**CANBY ID 16, NON-EXISTING WTS AT S MULINO RD - LOCATION OF PROPOSED C800 FACILITY**

## C-800 Canby Neighborhood Meeting Notes for Meeting held 11/1/16 7PM

**TO:** Skip Greene, Representative for Clackamas 800 Radio Group  
**RE:** PRA 16-14 Pre-Application Conference for Clackamas 800 Radio Group Lattice Tower  
**FROM:** Bryan Brown, Planning Director  
**DATE:** September 13, 2016

**BEFORE THE PLANNING COMMISSION  
OF THE CITY OF CANBY**

**LANDSCAPE PLAN**

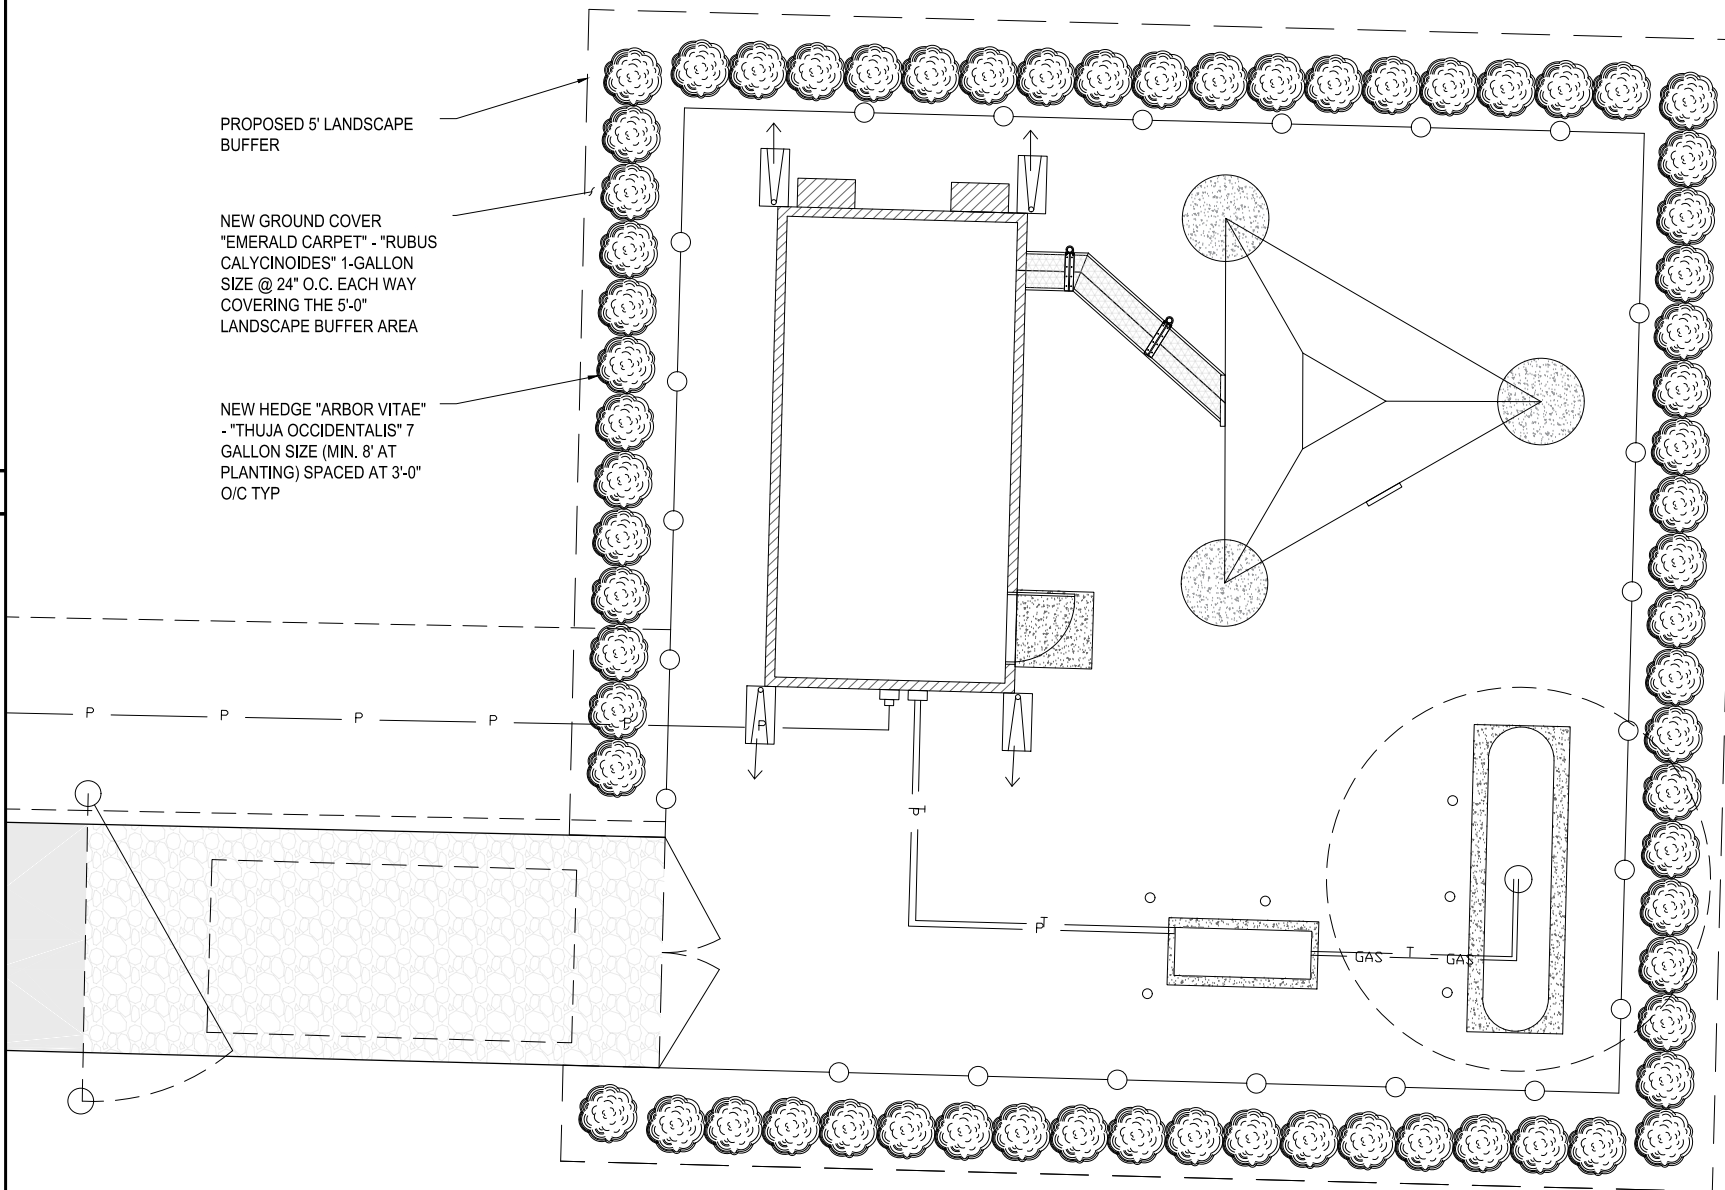
4. All landscaped areas are required to be irrigated per 16.35.050(M) and 16.49.120(H) or provided with an irrigation outlet within approximately 150 feet of all plant materials to be maintained

unless the Planning Commission accepts an alternative method to keep the plant material alive since water service is not otherwise planned to be extended to the site. This condition requires the applicant provide periodic hauling of water to the site until the plant material is adequately established. If the applicant fails to keep the plant material alive, the City reserves the right to require C800 Group to install water service to the site to irrigate and if necessary replant dead plant material to maintain the approved Site landscape materials.
